Statement for Public Inquiry
Amanda Mullarkey
On behalf of Guildford Residents Associations

APP/Y3615/W/20/3260509

1-5 The Quadrant, Bridge Street and The Casino Nightclub, Onslow Street, Guildford, GU1 4SQ

Figure 2: Flood Map for Planning
(Source: gov.uk website)

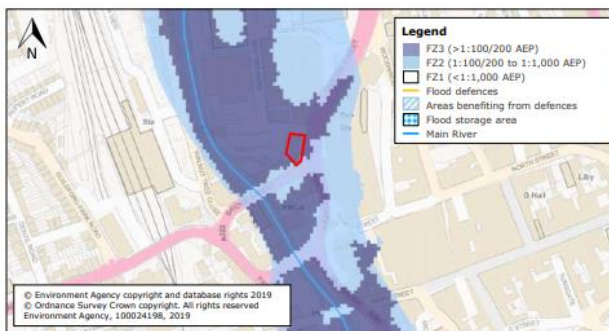
- The site has high flood risk (zone 3). When the river last flooded in 2013, the waters rose before warnings were issued even though monitoring was supposedly in place. It is a flashy catchment. The grave consequences of flooding, with possible loss of life, are greatly increased by the proposed use of the double basement for a range of possible leisure uses, including night club, and the fact many people to be evacuated from the top two floors are likely to have been drinking.

- Much reliance is placed on ground floor finished floor levels of 32.76m AOD. This was described in the Flood Risk Assessment as a conservative estimate. The model was too unstable to be able to derive flood levels for a 1 in 100, plus climate change at 70%, annual probability event. River flooding to be expected from a 1 in 100, plus climate change at 35%, annual probability event would be a depth of .95m flowing at .51m per second.
- We ask the Inspector to satisfy himself that the proposed minimum slab level is met. The land drops by about a metre from one end of the building to the other. Only in the very south east corner is the land at 32.76m AOD. Various floors and doors are at different levels and inconsistent.

Figure 4: Environment Agency Historical Flood Map
(Source: gov.uk website)

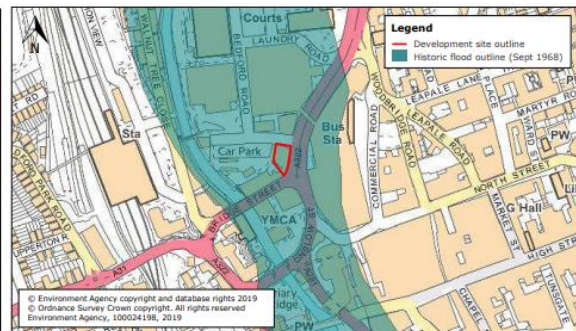
- P4.2b) The proposal passes neither the sequential nor exception test. The sequential test shows many alternative sites for student accommodation on land less vulnerable to flooding. The proposed exit route would be into an area of flood risk and that flooded in 1968. It would involve wading through flood water.
